**STATEMENT OF CASE
FOR
ARGYLL AND BUTE COUNCIL
LOCAL REVIEW BODY**

**REFUSAL OF PLANNING PERMISSION FOR SUB-DIVISION OF
GARDEN GROUND AND ERECTION OF DWELLINGHOUSE.**

**REAR GARDEN GROUND OF 6 STEWART STREET, KIRN,
DUNOON, ARGYLL.**

**PLANNING PERMISSION APPLICATION
REFERENCE NUMBER 13/00594/PPP**

REF	M112 GL/PH
PROJECT	REDEVELOPMENT OF 10A STEWART STREET, DUNDEE AND F.L. FIVE (D)
DATE	AS EXISTING BLOCK PLAN (A3)
SCALE	1:100
DATE	21-03-13
BY	C & S Architects
FOR	10A STEWART STREET, DUNDEE AND F.L. FIVE (D)

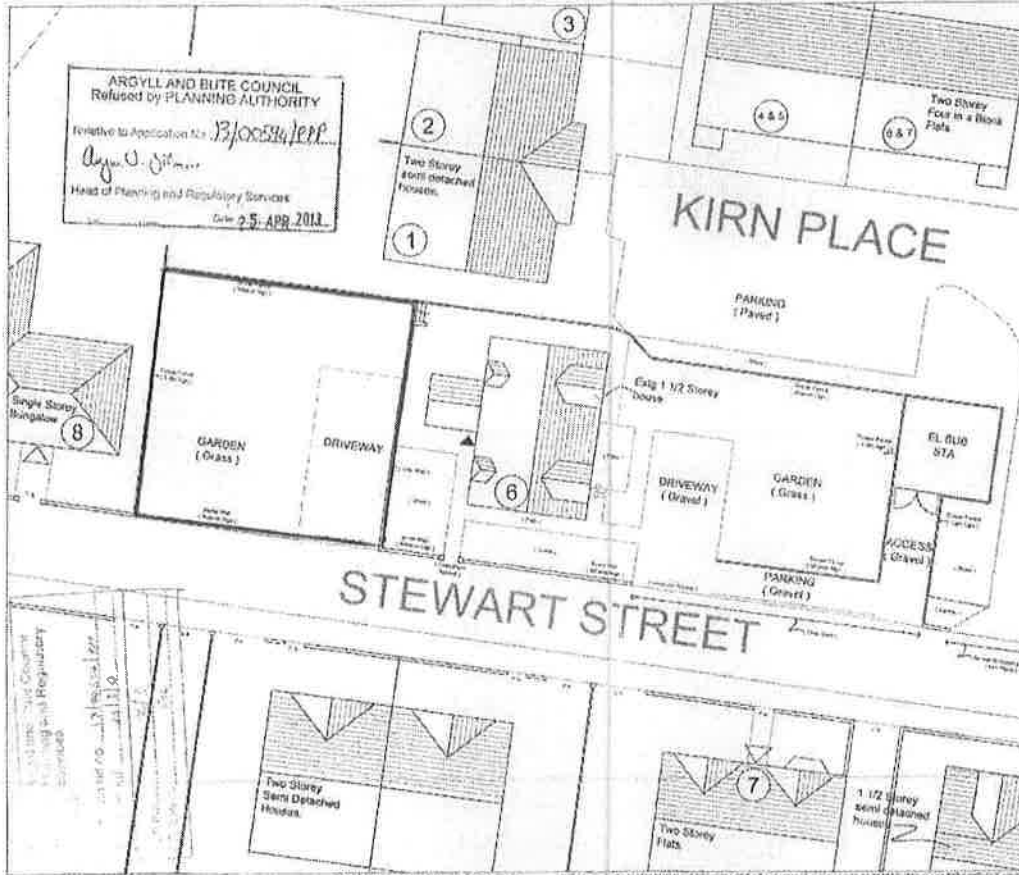
New houses to be two storey & max. 13.0 sq m GIFA
 SITE AREA = 229 sq m
 FOOTPRINT = 86 sq m
 AMENITY SPACE = 102 sq m

Existing 1 1/2 storey house retained
 SITE AREA = 490 sq m
 FOOTPRINT = 87.5 sq m
 AMENITY SPACE = 307.5 sq m

Drawn	MSP/C/CFM
Project	NEW DWELLING HOUSE 64 STEWART STREET DUNDEE ARGYLL PA32 5EB
Client	AS PROGRESS BLOCK PLAN
Project No.	13/00534
Scale	1:100
Date	16/4/13

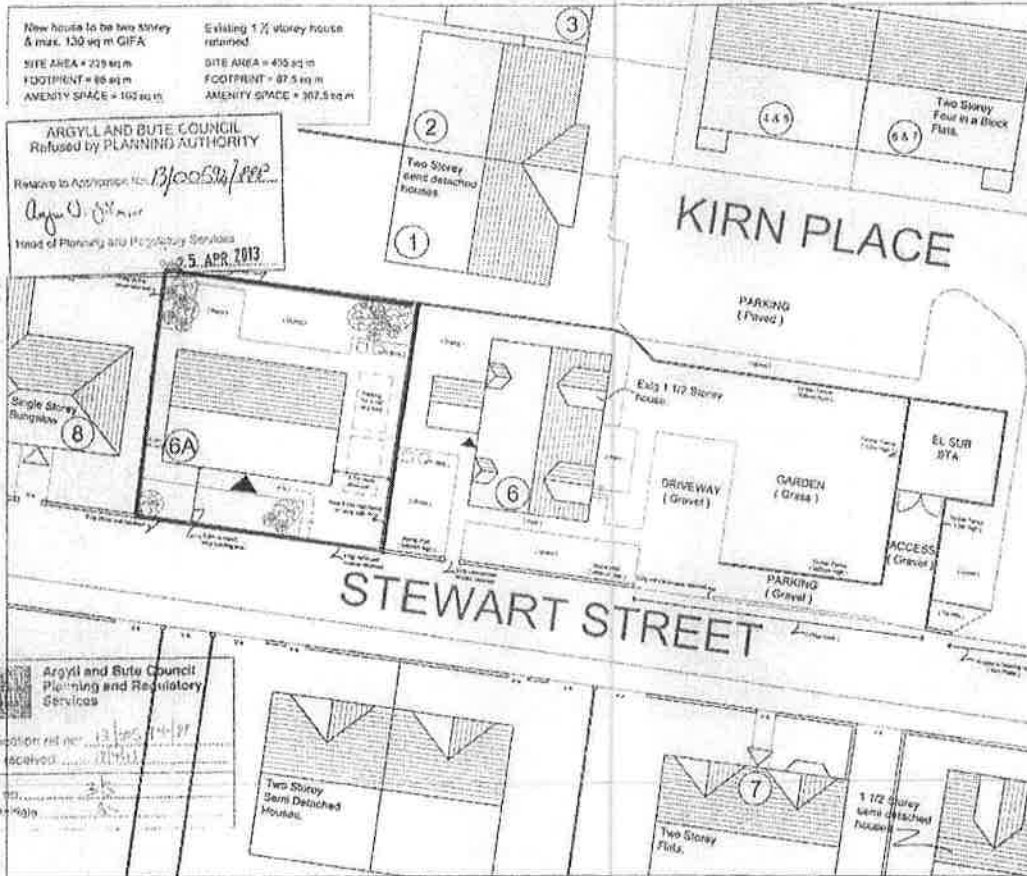
Comment: The application site measures 15 x 15 metres (225sqm) with an indicative building footprint of 10.4 x 7 metres (73sqm). The proposed building footprint would be located 2.6 metres from the east facing side elevation of the adjacent bungalow at 8 Stewart Street. The proximity of the proposed two-storey dwellinghouse to the adjacent bungalow would result in a significant loss of daylight to the sole bedroom window on this side elevation and also result in visual dominance from such a tall structure in very close proximity to a lower building. The proposed dwellinghouse would be sited 4.8 metres from the northern boundary with the adjacent semi-detached dwellinghouse at 1 Kirn Place. This could result in overlooking of the private rear garden area. The proposed dwellinghouse would be sited 13 metres from the front elevation of the adjacent semi-detached dwellinghouse Narnain, 12 Stewart Street. This could result in normal window-to-window distance (18 metre minimum for directly facing windows) being compromised with overlooking and privacy issues for the adjacent property

Comment: The application site measures 15 x 15 metres (225sqm) where the indicative building footprint of 10.4 x 7 metres (73sqm) occupies approximately 32% of the plot. Whilst the plot density generally meets the requirements in the Local Plan, the undeveloped portion of the application site would comprise mainly driveway and hard areas with very limited private amenity spaces. The small garden area to the front measures 10 x 2 metres (20sqm) but this is regarded as fore garden space and not meaningful amenity space. The small garden area to the rear excluding the footpath measures approximately 45sqm and general depth of 4 metres. This is considered to be very limited in terms of comparison with surrounding dwellings. The proposal would also result in the loss of rear garden ground for the donor property at 6 Stewart Street. This property currently has a rear garden extending to 17 metres which would be reduced to 1.5 metres.
